Cindy Kauffman 3993 Mapleton dr. West Linn: I requested a continence because 5 neighbors that could be affected by the development were not able to attend the last meeting.

My points of concerns are: In the Supplemental Storm Analysis Report on November 2018 (On paragraph 4 Mr. Goldson stated)

Upper deck view pre-flood 1996

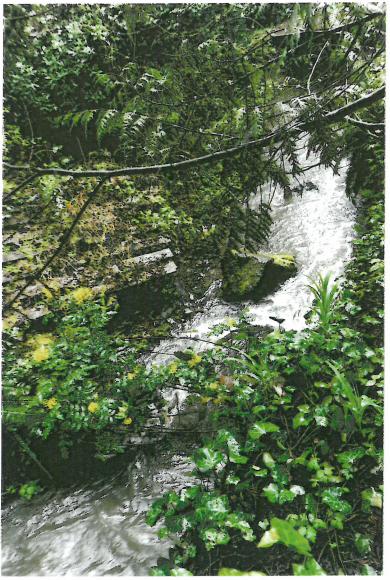
3'+ diameter log over creek was lifted off the bank into creek during the flood of 1996

3) April 6thwest to east entranceTo my property flowingto bridge 1" rain day

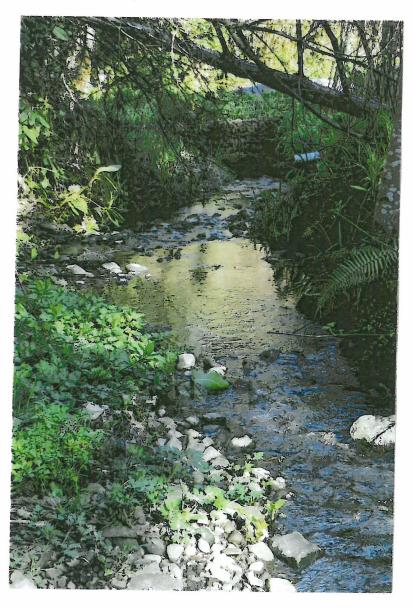
Bridge we rebuilt due to erosion

3.5) March 30th
West bottom east top
of picture

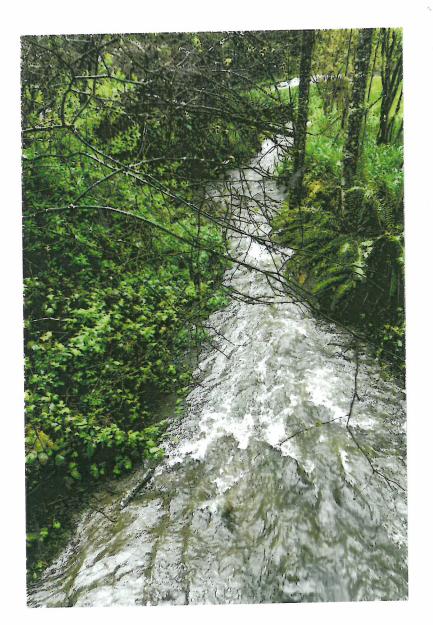
April 6th with 1" Rain same place

4) March 30th

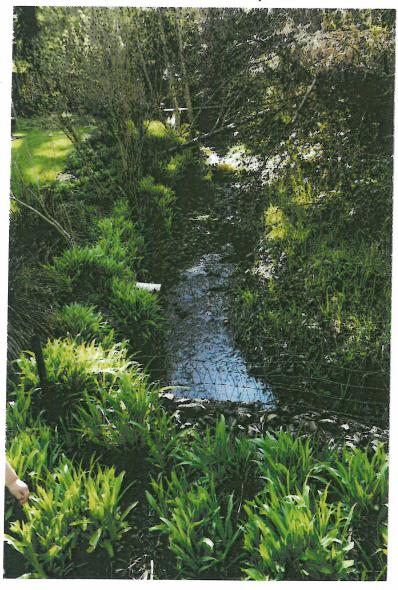
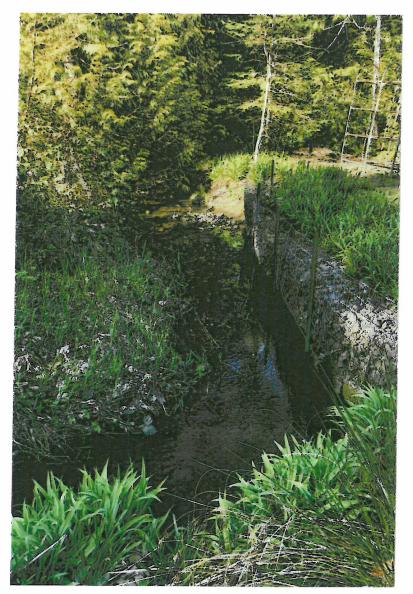
East-bottom west-top

April 6th with 1" Rain same place

5) March 30th90 degree turn in creekRock support

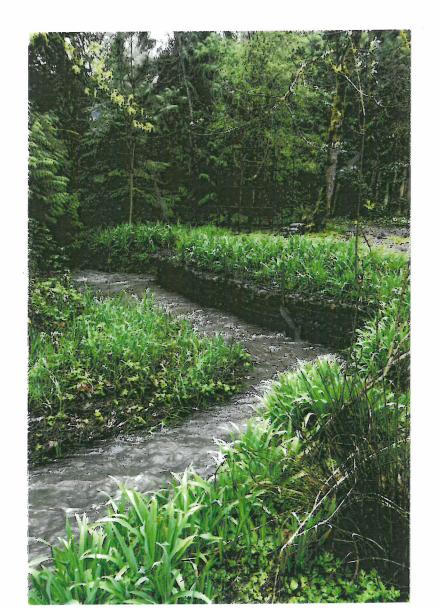
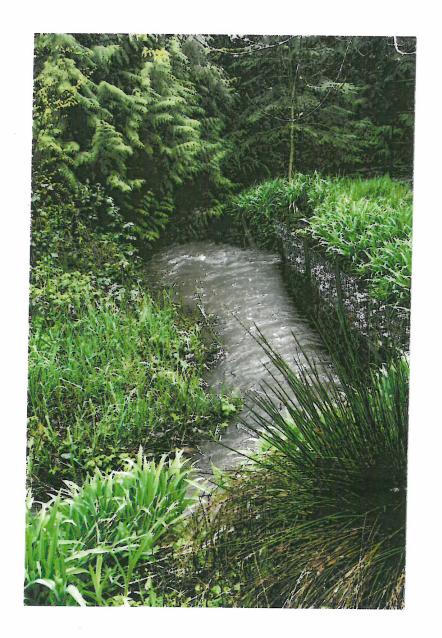
April 6th with 1" rain fall same place

6) April 6th90 degree turn in creekCloser view of rock support on1" of rain day.

7) March 30th
View past rock wall where creek
Curves

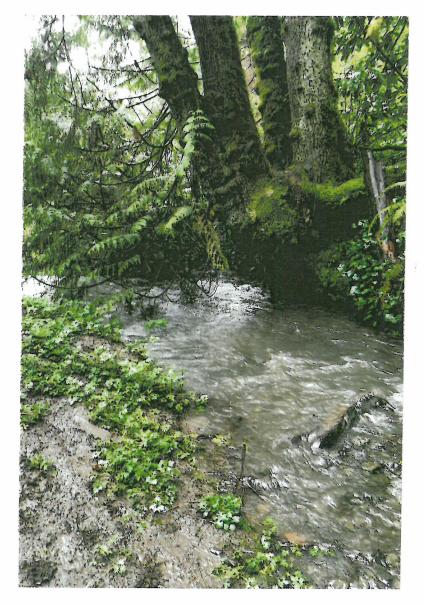
April 6th shows erosion under trees at the same curve with 1 " rain

8) March 30th View just before creek Enters neighbors to east.

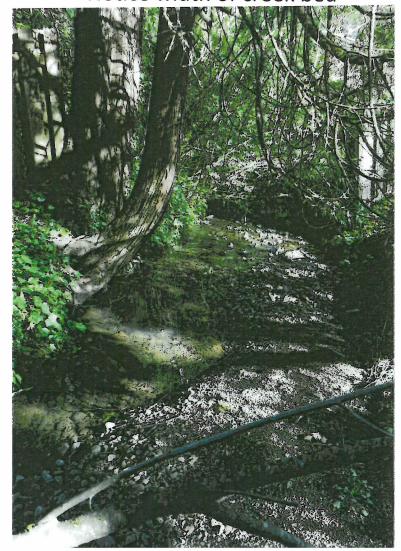
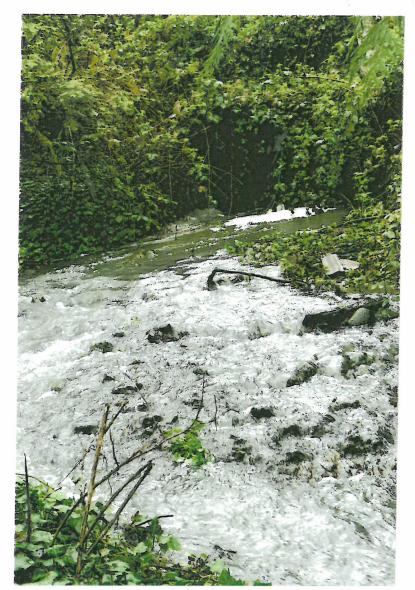
Notice width of creek bed

same view shows deeper trench

Due to rock (cobble) that washes down

and changes creek bed flow and width
